Serial No. NA3-15-018
Docket No. 52-017
COL/DBE

DOMINION VIRGINIA POWER
NORTH ANNA UNIT 3 COMBINED LICENSE APPLICATION
SUBMISSION OF REVISED SEISMIC RAI RESPONSES AND COLA MARKUPS

RAI No. 7520, Question 03.07.01-7

RAI No. 7520, Question 03.07.01-11

Figure 4 RB/FB SSI Stand-Alone Partially Embedded Model

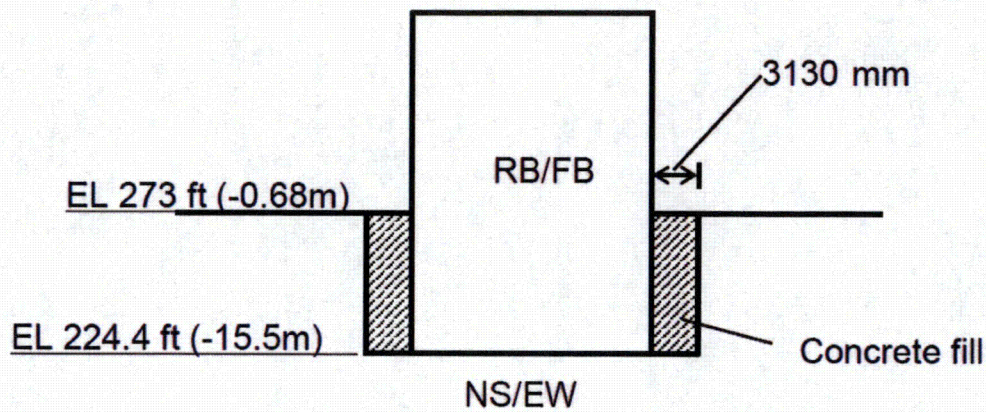
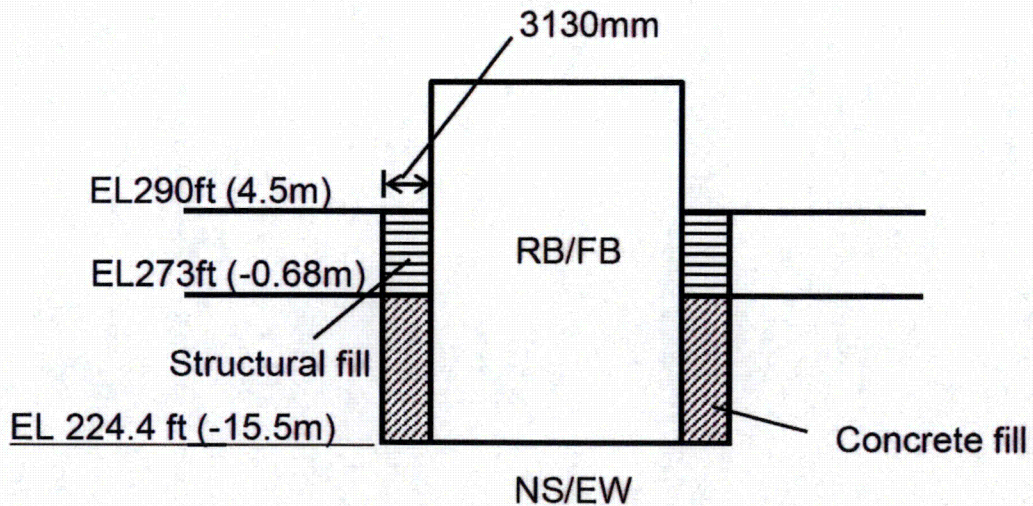
The staff requested that the applicant provide the technical basis for computing FIRS and PBSRS which only considers soil/rock columns with in-situ saprolite and not the granular or concrete fill that will be surrounding or beneath the Seismic Category I structures up to the finished grade elevation. The applicant responded to this RAI in their July 3, 2014 letter (NA3-14-030). The staff provided feedback to the applicant on this response during the public conference call on July 10, 2014. The applicant was requested to further address the following and update the FSAR accordingly:

- Since the effect of backfill material on the structural response may be important the RAI response should reflect this.
- The extent of the backfill material could not be determined from the FSAR Figure 2.5.4-206. As such, the figure should be revised or additional figures should be referenced in the FSAR that provide the extent of the backfill.

The partial and full embedment configurations considered in the RB/FB and CB SSI analyses provide responses that bound the effects of subgrade stiffness variations related to the backfill horizontal extent and minimize the effects of dissipation of energy in the SSI system due to damping of the embedment materials. The partially embedded models provide a lower bound representation of the stiffness of the RB/FB and CB embedment because they do not consider the stiffness of the subgrade materials (saprolite and the structural fill) above Zone III rock surface. Because the structural fill has a lower shear wave velocity (and thus lower shear modulus and stiffness) than the surrounding in-situ saprolite, the fully embedded model with a minimum horizontal extent of the structural fill provides an upper bound representation of the stiffness of the RB/FB and CB embedment. Furthermore, the use of the minimum horizontal extent of the structural fill material minimizes the dissipation of energy in the embedment soil is conservative because, as shown in Figures 2 and 3, the structural fill has a higher material damping ratio than that of the in-situ saprolite. The comparisons between the shear wave velocity and damping ratio of the structural fill and in-situ saprolite are provided in Figures 2 and 3 below, which show that the structural fill has lower stiffness and higher damping properties than the surrounding in-situ saprolite. Therefore, the use of minimum values and LB dynamic properties for the structural fill horizontal extent results in SSI models of fully embedded RB/FB and CB that maximize the stiffness and minimize the damping of the embedment above Zone III rock. The envelope of responses obtained from site-specific SSI analyses of partially and fully embedded models bound variations of subgrade stiffness related to backfill horizontal extent and corresponds to a lower dissipation of energy in the SSI system due to damping of the subgrade materials located above Zone III rock surface.

The lateral extent of the fill in the RB/FB and CB models is taken to be the smaller of one-half of the fill width between adjacent structures or the actual fill width to the inside face of the sheet piling on the sides without adjacent

Two structural models are used for site-specific RB/FB SSI analyses performed for LB, BE and UB partial and full column subgrade profiles. The configurations of the partially embedded and fully embedded RB/FB SSI models are shown below in Figures 4 and 5. The minimum value of the lateral extent of backfill for the RB/FB SSI model is 3130 mm (10.27 ft) and is determined as one-half of the distance between the RB/FB and the adjacent Turbine Building (TB) as shown in Table 1, which is the same as the minimum distance to the inside face of the sheet piling on the South and West sides of the building. The concrete fill that will be placed under the northern edge and southeast corner of the RB/FB basemat is considered as part of the far-field in-situ Zone III/IV rock because, as described in FSAR Section 2.5.4.2.5, the dynamic properties of the concrete fill are very close to that of the Zone III/IV rock.

Figure 1. Overlay of FSAR Figures 2.5.2-290 and 2.5.2-292 (ARS at 10^{-4} hazard level)

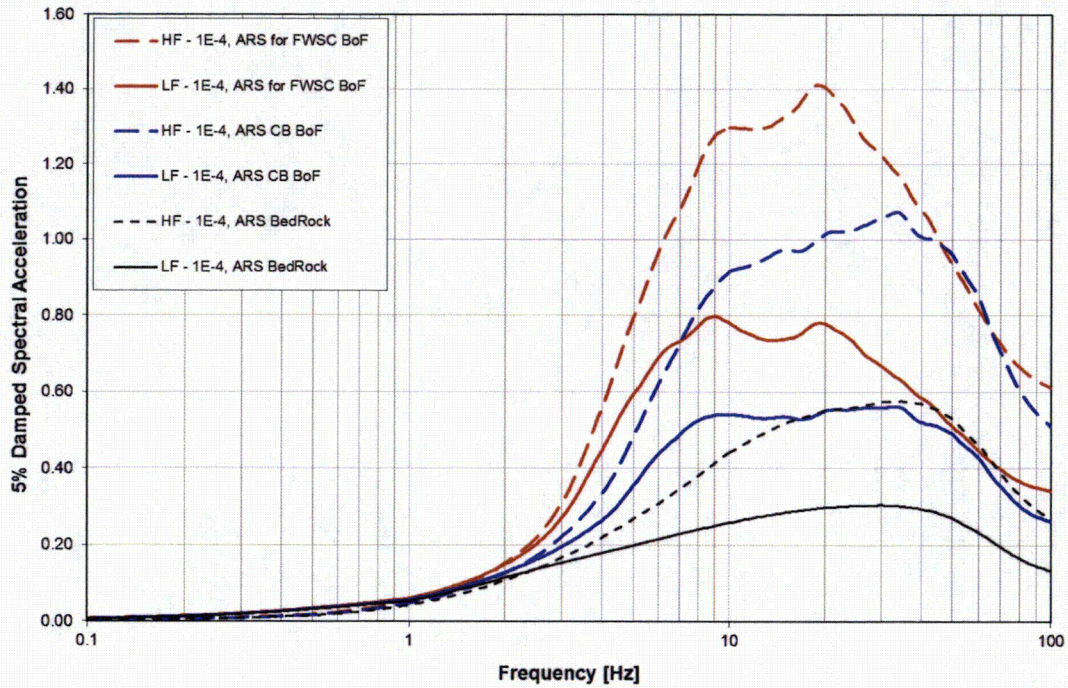
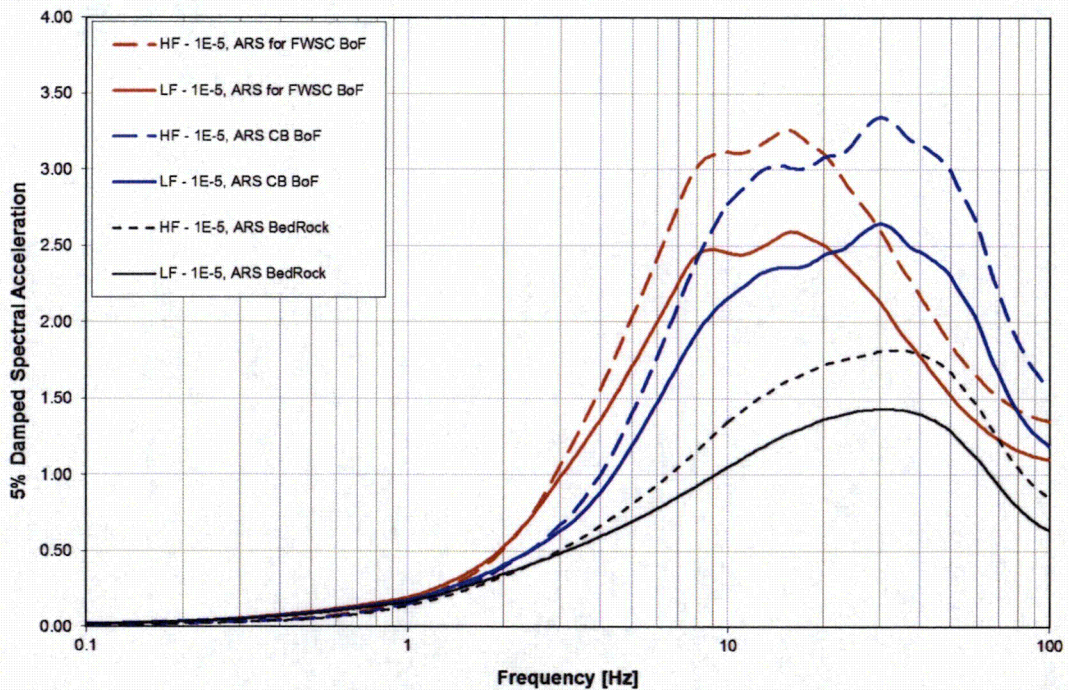
(b) Explain why the FWSC SSI input response spectra shown in FSAR Figure 3.7.1-234 differs substantially from the SSI input response spectra for the CB shown in FSAR Figure 3.7.1-231, both in amplitude (lower) and in frequency content (shift to lower frequencies), even though the FWSC is situated at a higher elevation and is supported on similarly stiff material.

The FWSC SSI input response spectra shown in FSAR Figure 3.7.1-234 has lower amplitudes and lower frequency content when compared to the CB SSI input response spectra presented in FSAR Figure 3.7.1-231 most importantly because the FIRS elevations and supporting in-situ materials below the FIRS elevations for these two buildings are significantly different. Note that the best estimate soil profiles corresponding to the FWSC and the CB are close but not identical as presented in FSAR Figures 2.5.2-259 and 2.5.2-262.

The comparison of the 10^{-4} hazard level acceleration response spectra (ARS) in Figure 1 shows FWSC responses generally have higher amplitudes and lower frequencies, relative to the CB responses. At 10^{-5} hazard level, a more pronounced shift in frequency content is observed in Figure 2 for the FWSC motion as well as a slight reduction in the amplitude of the high frequency peaks due to nonlinearity effects in saprolitic soils. Following the RG 1.208 approach in calculation of design response spectra, these nonlinearity effects at 10^{-5} hazard level lead to a smaller ratio of 10^{-5} to 10^{-4} ARS (this ratio is referred to as AR) and significantly smaller design factor (DF) at higher frequencies for the FWSC. Comparisons of the AR and DF parameters for the FWSC FIRS at Elevation 282 ft and the CB FIRS at Elevation 241 ft are shown in Figure 3. Finally, FSAR Figures 2.5.2-301 and 2.5.2-306 of the FSAR are overlaid in Figure 4 which compares the envelope of the HF and LF ARS (denoted as Env ARS) at 10^{-4} and 10^{-5} hazard levels as well as the FWSC DRS (Elevation 282 ft) and the CB DRS (Elevation 241 ft). The comparison shows a similar amplitude of the FWSC DRS compared to the CB DRS and a notable shift towards lower frequencies which are consistent with the SSI input response spectra presented in FSAR figures 3.7.1-234 and 3.7.1-231.

Figure 8. 5% Damped Final SSI Input Response Spectra at Elevation 220 ft (Average Elevation of Bottom of Concrete Fill) for FWSC

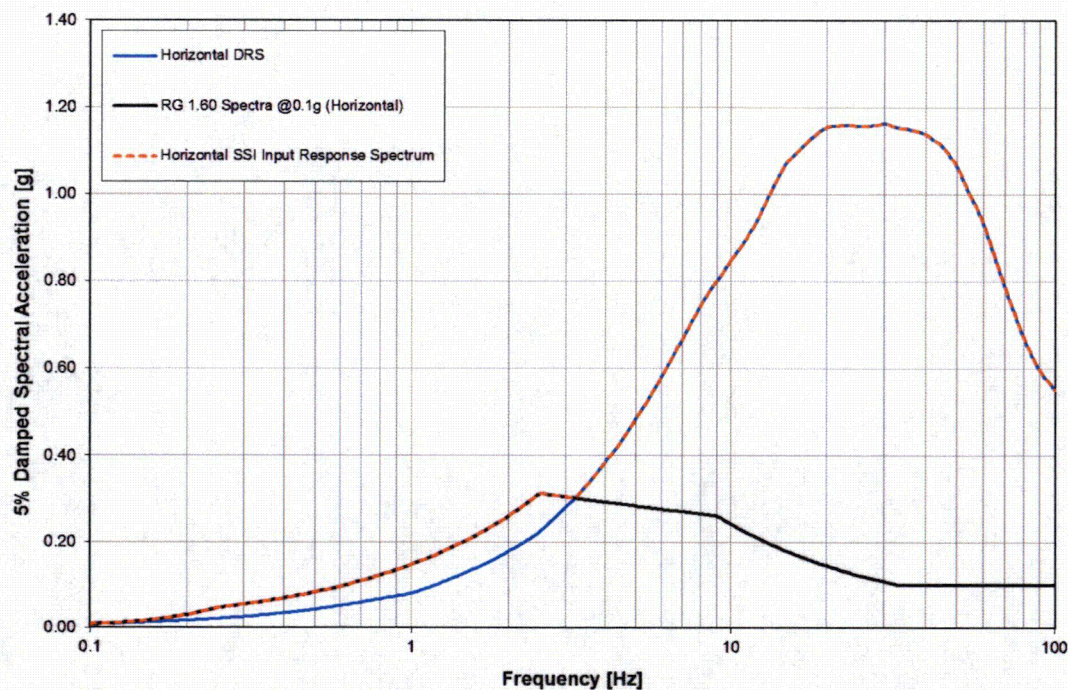
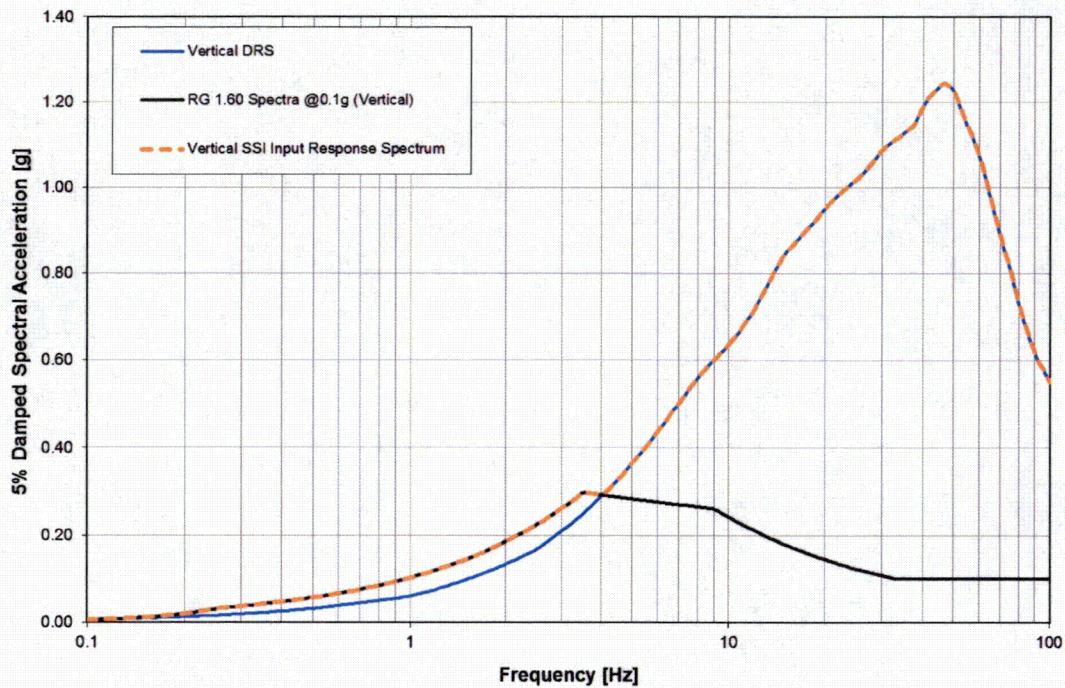
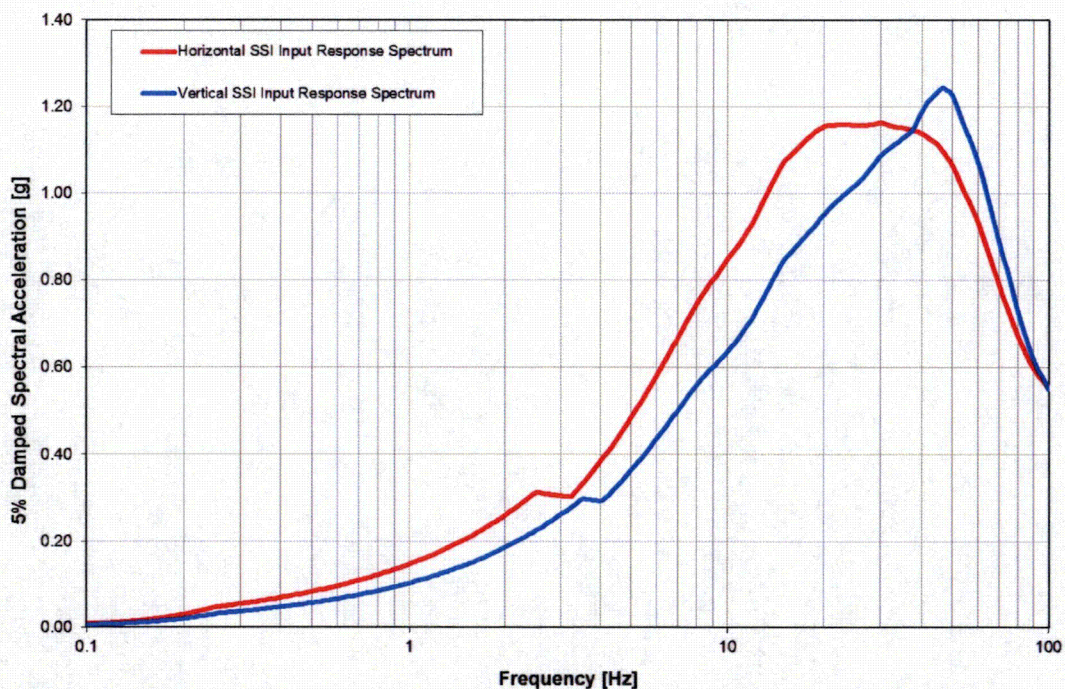
(a) Provide the technical justification for defining the control motions used in the SSI analysis at the bottom of the basemat and not at the bottom of the concrete fill. Staff notes that, from the point of view of the SSI analysis, the combined FWSC-concrete fill is an embedded structure and as such, the control motions for SSI analysis should be defined at the bottom of the concrete fill to be consistent with the NEI approach. The NEI check should be applicable in this case.

To address this potential high frequency deamplification of the input motions, the FSAR methodology regarding the control motion for SSI analysis of the FWSC (FSAR Section 3.7.1.1.4.2.3) is supplemented by adding new horizontal and vertical SSI input response spectra at the average elevation of the bottom of the concrete fill at Elevation 220 ft (corresponding to the average elevation of the top of Zone III-IV rock). Furthermore, FSAR Section 3.7.2.4-1 will be supplemented to describe the new SSI analysis and design basis for the FWSC. The new SSI input response spectra are calculated as the envelope of the design response spectra (DRS) at Elevation 220 ft and the minimum

required response spectra (which are adopted from the broadband spectra defined in RG 1.60 and anchored at 0.1g at peak ground acceleration (PGA)). The DRS at Elevation 220 ft are calculated consistent with the existing FIRS for the FWSC (Elevation 282 ft) using the same methodology as described in FSAR Sections 2.5.2.5 and 2.5.2.6. The mean horizontal outcrop uniform hazard response spectra (UHRS) at 10^{-4} and 10^{-5} hazard levels and outcrop DRS for FWSC soil column at Elevation 220 ft are presented in Figure 5. The development of the horizontal and vertical SSI input response spectra at Elevation 220 ft is provided in Figures 6 and 7, respectively. The final SSI input response spectra at Elevation 220 ft are presented in Figure 8. An additional set of SSI analyses ~~is performed~~~~will be performed~~ using the new SSI input response spectra with the control point at Elevation 220 ft corresponding to the bottom of the concrete fill in the SSI analysis model. Note that since the new SSI input response spectra (at Elevation 220 ft) is calculated to be consistent with the SSI input response spectra at Elevation 282 ft, the LB, BE, and UB strain compatible properties provided in FSAR Section 3.7.1.1.4.1.3 are applicable to the additional set of SSI analyses.
